**RE: Lincoln Drive Median Access from Mockingbird Lane to the Eastern Town Limits**

Subject: Lincoln Drive, Mockingbird Lane to Town of Paradise Valley (TOPV) Jurisdiction  
Median Breaks and Access  
Third Party Traffic Review Comments

As requested by Town Staff, Kimley-Horn has conducted a third-party traffic review of the Lincoln Drive Access Assessment Exhibits (Options 1 through 3) prepared by CivTech for Lincoln Drive, from Mockingbird Lane to the TOPV jurisdictional boundary. We understand that raised medians are proposed for installation as part of the TOPV capital improvements projects. We also understand that two developments (Smoke Tree Resort and Lincoln Medical Plaza) are also proposed within the corridor. The developments will generate additional traffic and would like to maintain full access to their parcels from Lincoln Drive. The purpose is to review each of the Access Assessment Options, traffic analysis, and data provided by CivTech. Kimley-Horn's (KH) evaluation and review consisted of the following:

Figure 4.2 Process for Selecting Average Rate or Equation  
in Trip Generation Manual Data

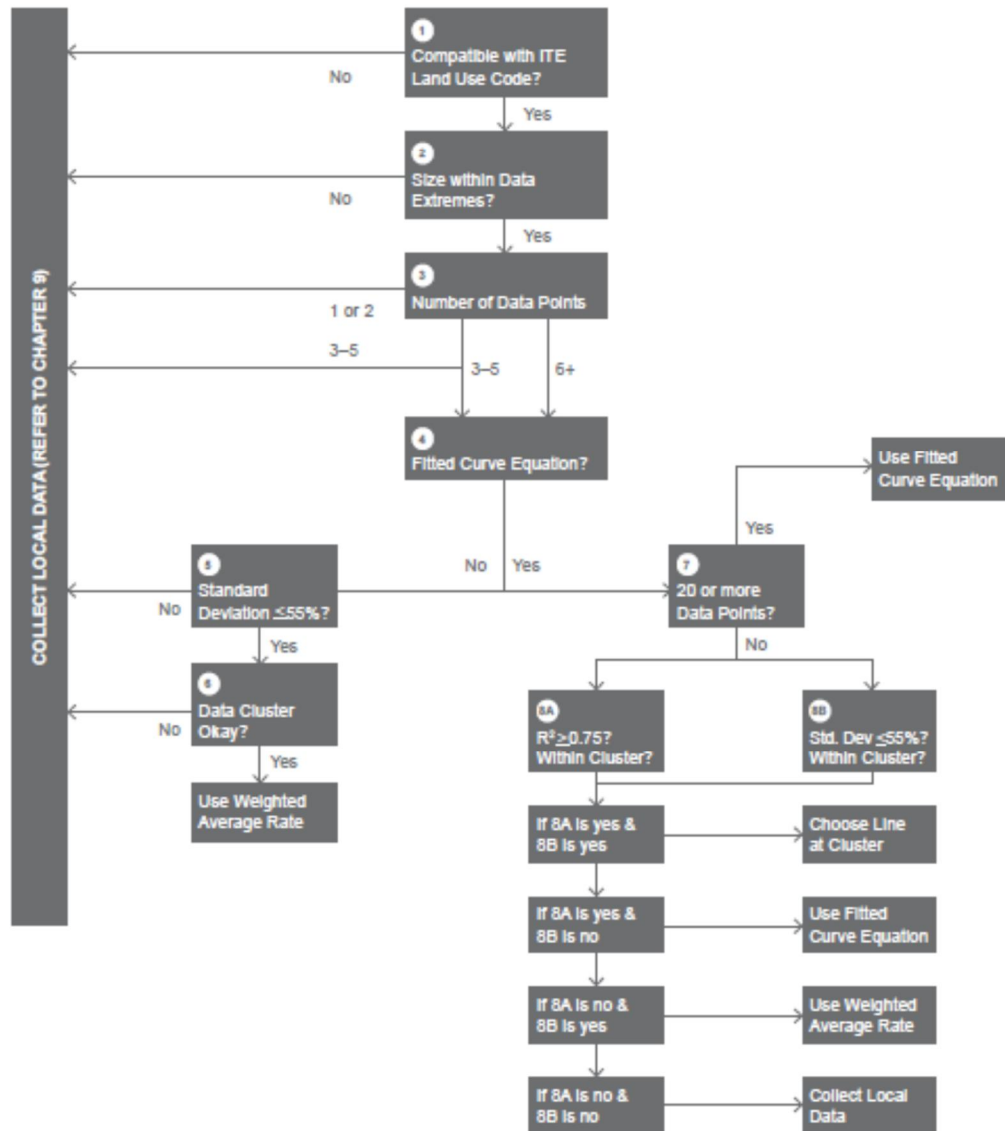
**KH Comments 4:** Smoke Tree Resort utilized equations as opposed to average rates. KHA went through the ITE Trip Generation Handbook process presented in Figure 4.2 assuming proposed number of units for resort hotel (LUC 330). The results of this process are presented below and KH redlines provided in **Appendix 1**.

Because the rooms are not within the data extremes and the R2 value is less than 0.75, we recommend the weighted rates be used. Using the rates as opposed to the equation results in double the trips being generated in the AM peak hour.

**Response to Comment 4:** CivTech has updated the trip generation rates to reflect a blended rate between LUC 310 and 330 as discussed in response to comment #3. The trip generation calculations were also revised to reflect 150 rooms, 30 residential units, and 3500 square foot quality restaurant. The revised trip generation calculations and approach were considered acceptable. The revised trip generation calculations, based on 150 rooms, 30 residential units, and 3500 square foot quality restaurant, are provided in **Appendix 2**.

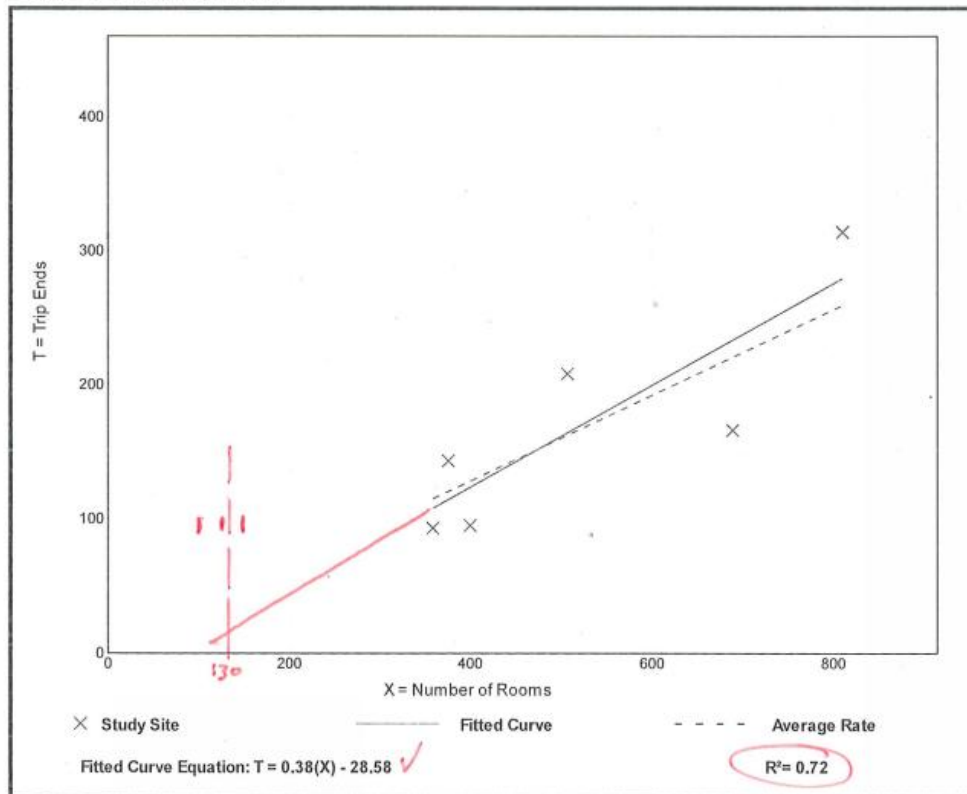
- The number of rooms is way out of range of the data extremes; the lowest number of rooms in the manual is roughly 370 compared to the 132 that are proposed
- If you follow the equation, which happens to be a straight line and not a logarithmic function, then 132 rooms will generate a very low number of trips
- The number of data points is equal to 6
- The R2 value is close to the required 0.75, so you could argue it either way
- The standard deviation is less than 55% of the average rate

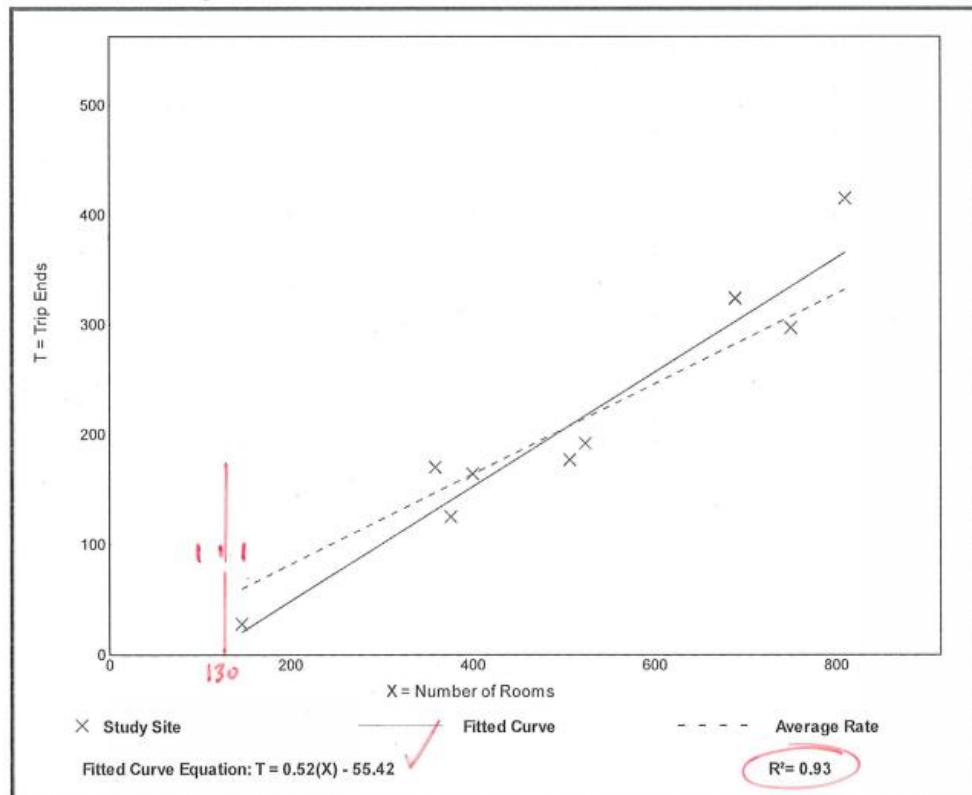
- The number of rooms is just outside of the data extremes
- The number of data points is greater than 6
- The R2 value is well above the required 0.75
- The standard deviation is less than 55% of the average rate

Because the number of data points and the R2 value are high enough and the standard deviation requirement is met, the use of the equation during the PM peak is appropriate.

SHEET  
Opt-01  
01 OF 03

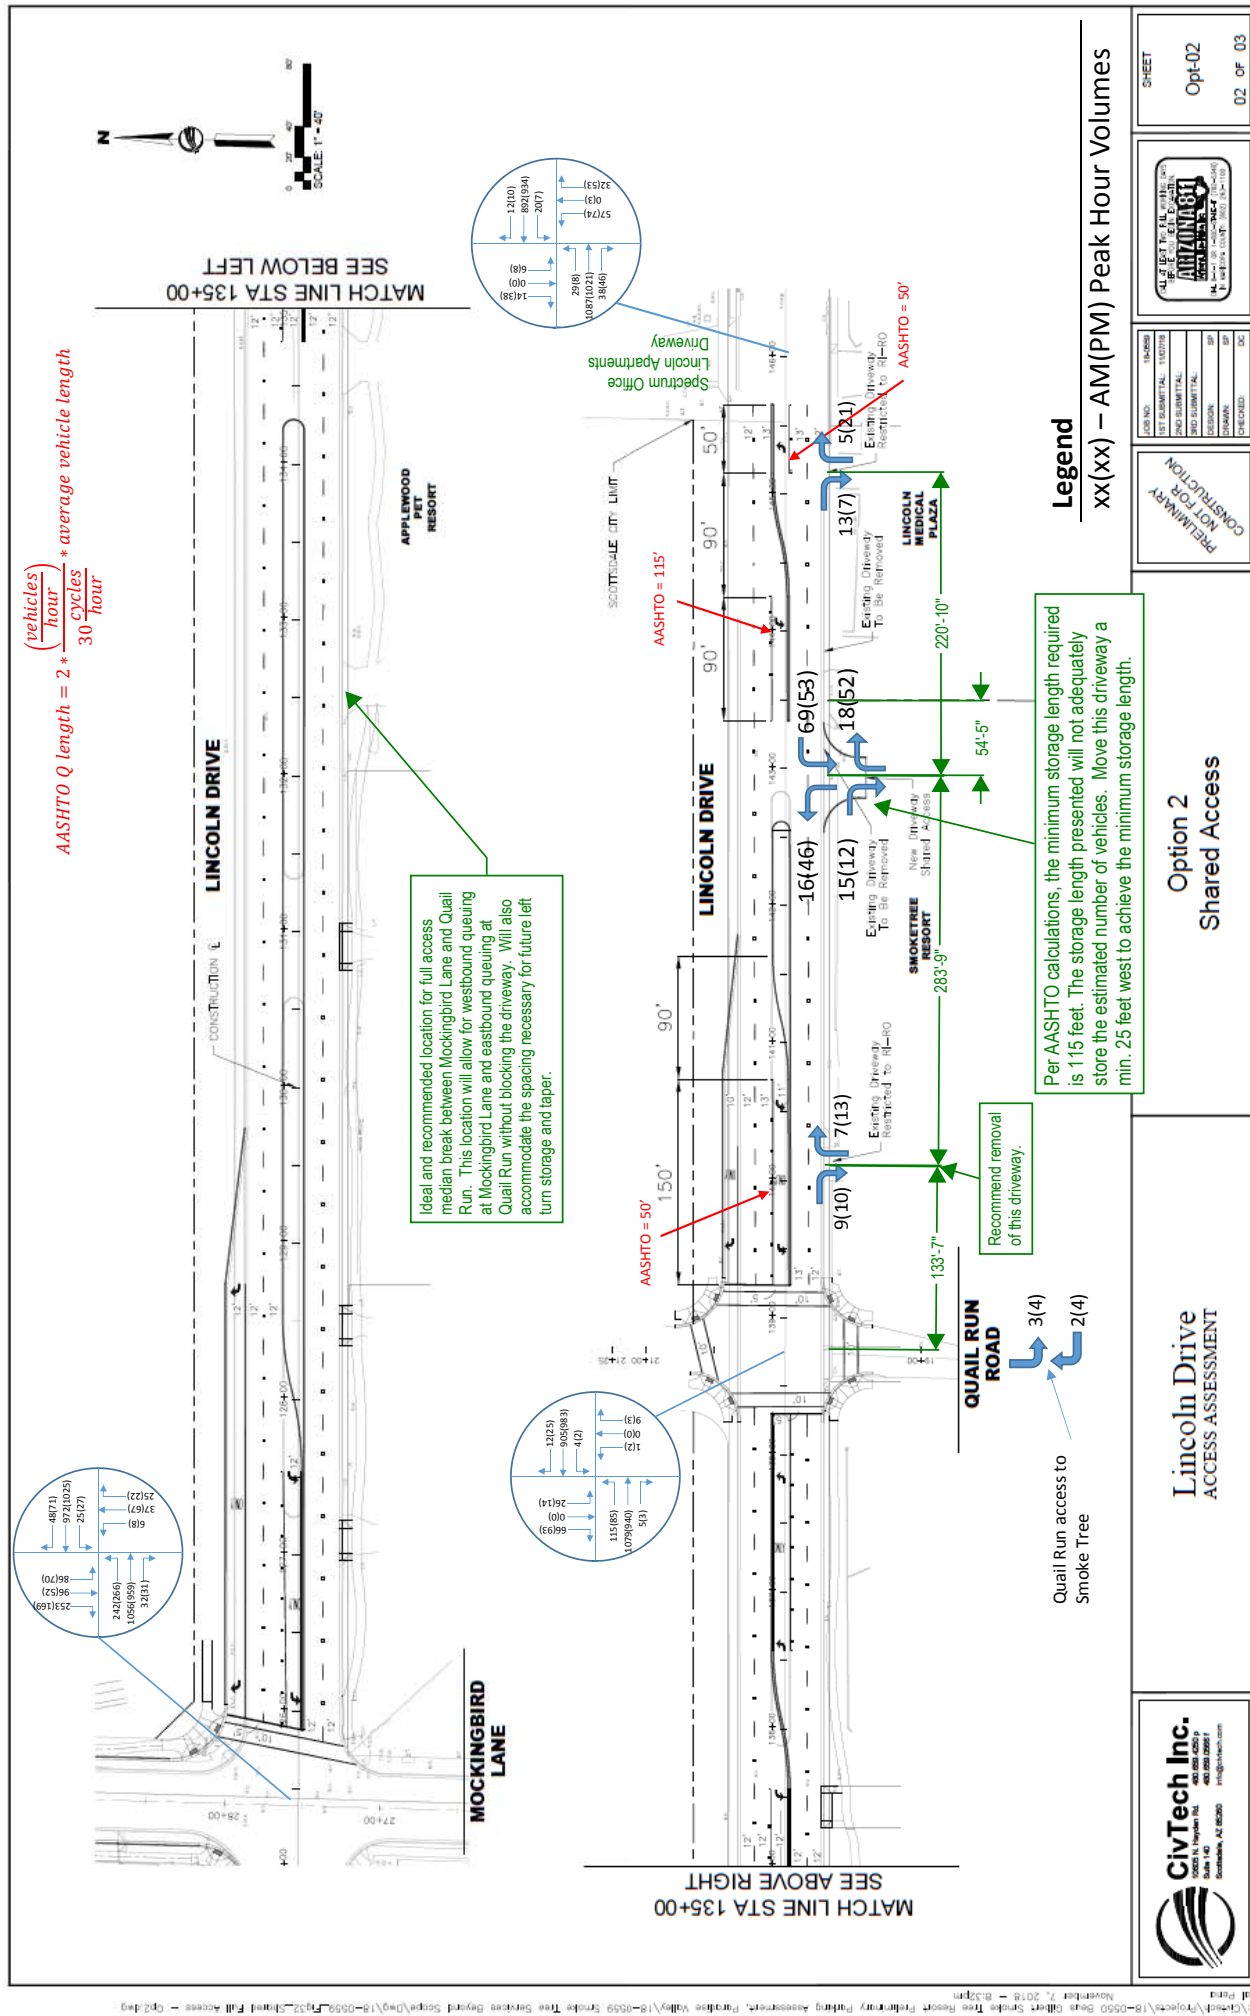
**KH Comment 10:** Storage length at Spectrum Office Driveway/AJ Driveway calculation ((29 vph x 25 feet x2)/30) is 48 feet. Per AASHTO, the minimum storage length is 50 feet. Exhibit illustrates a minimum of 50 foot being provided. This is considered acceptable.

**KH Comment 11:** As shown in Option #1 exhibit, access improvements include closure of the existing eastern access on Smoke Tree Resort, a new Smoke Tree Resort access approximately 183 feet west of Lincoln Medical Plaza access, and the existing Smoke Tree Resort western access to remain as right in/right out. The proposed improvements result in the following spacing (centerline to centerline) of driveways:

**KH Comment 12:** The storage length shown in Option #1 exhibit for Lincoln Medical Plaza is 70 feet. Per AASHTO calculations, storage length should be no less than 70 feet to adequately store the estimated number of vehicles generated by Lincoln Medical Plaza. This is considered acceptable. The storage length for the Smoke Tree Resort eastern driveway is 75 feet. Per AASHTO calculations, storage length should be no less than 55 feet to adequately store the estimated number of vehicles generated by the Smoke Tree Resort. This is considered acceptable.

**KH Comment 13:** As shown in Option 1 exhibit prepared by CivTech, opening bay tapers are 40 feet at Smoke Tree Resort and 43-3" feet at Lincoln Medical Plaza. KH recommends that no less than a 90-foot opening taper be utilized to safely traverse traffic from the through lane to the left turn lane on Lincoln Drive, per the criteria and discussion on Page 4, 5, and 6 of this document. Kimley-Horn recommends the median be extended and access points to Lincoln Medical Plaza be restricted to right in/right out only movements for two reasons:
